## Technical modifications on baby at 230V

→ Starting from serial number: 13004308 dated 18/11/13  
table 1109-10 R01, pos. 7 – table 1109-20 R02, pos. 58

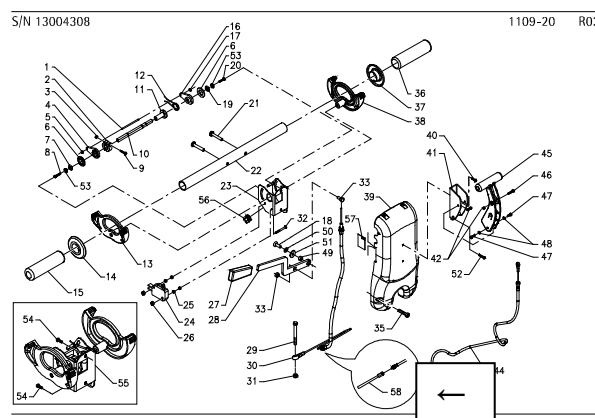
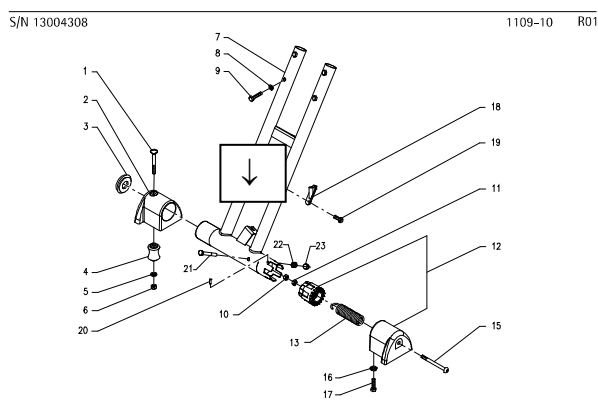
The handle bar tube has been replaced and an extension sheath has been inserted.

The guide system of the handle bar cable has been modified, already existing on baby 43. In the lower part of the handle bar tube the welded metallic curved end part has been taken off and an extension sheath for the cable has been assembled. The handle bar tube gets a new part number 21109030 and replaces part number 21109010.

Furthermore the extension sheath with part number 21009090 has been added.

This modification is applicable also to machines already produced replacing the handle bar tube and adding the extension.

→ Starting from serial number: 13003885 dated 22/10/13 – table 1112-10 R02, pos. 2 and 16

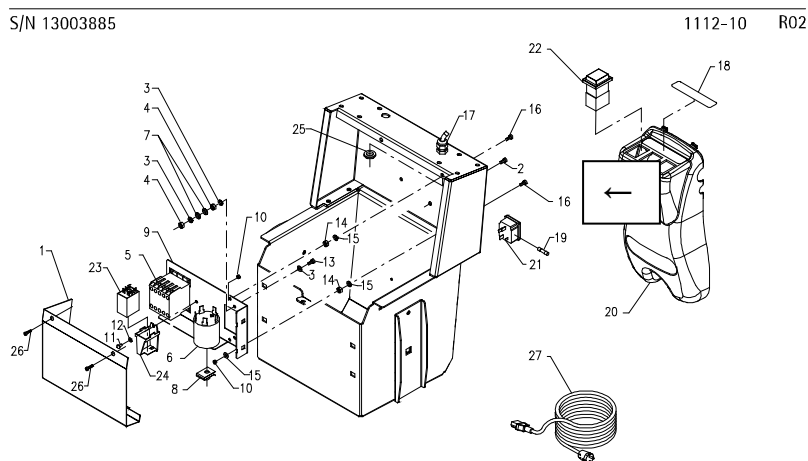
The white zinc-coated screws have been replaced with similar ones but black, already used on baby 43. These refer to the fixing screws of the electric panel and its protection.

Take off:  
pos. 2, 60140403  
pos. 16, 60140404

Add:  
pos. 2, 60140407  
pos. 16, 60140408
